UNITED STATES PATENT AND TRADEMARK OFFICE

APPLICATION NO.	FILING DATE	FIRST NAMED INVENTOR	ATTORNEY DOCKET NO.	CONFIRMATION NO.
09/816,603	03/23/2001	Mark Lynn Jenson	1327.009US1	6175

Office Action Summary

DETAILED ACTION

Figure 1

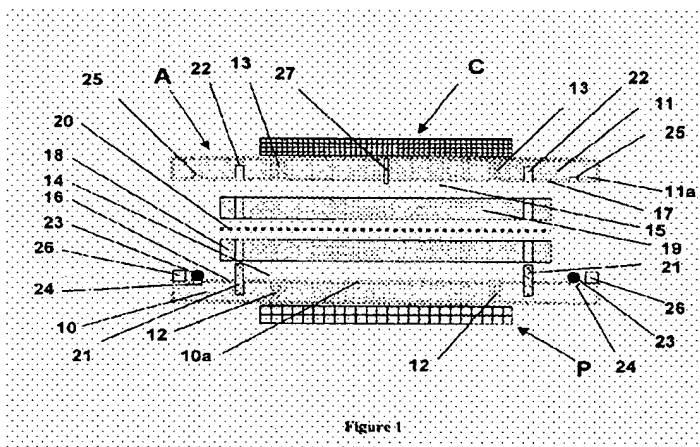
Shul et al further disclose the inclusion of a photovoltaic cell C and a power management circuitry P (COL 3, lines 29-35/ COL 2, lines 48-52). As apparent from **Figure 1** below, the

photovoltaic cell C is deposited on the battery (See FIGURE 1). Shul et al also disclose the a deep reactive ion etch process for treating the battery components (COL 2, lines 24-30 & lines 52-57/ COL 4, lines 32-40 & lines 46-55).

Given that Shul et al disclose the apparatus for fabricating the microbattery and the layered battery structure, thus, the specific substrate supply station(s) and deposition station(s)/means are inherently disclosed.

Figure 1 below illustrates the specific layered battery:
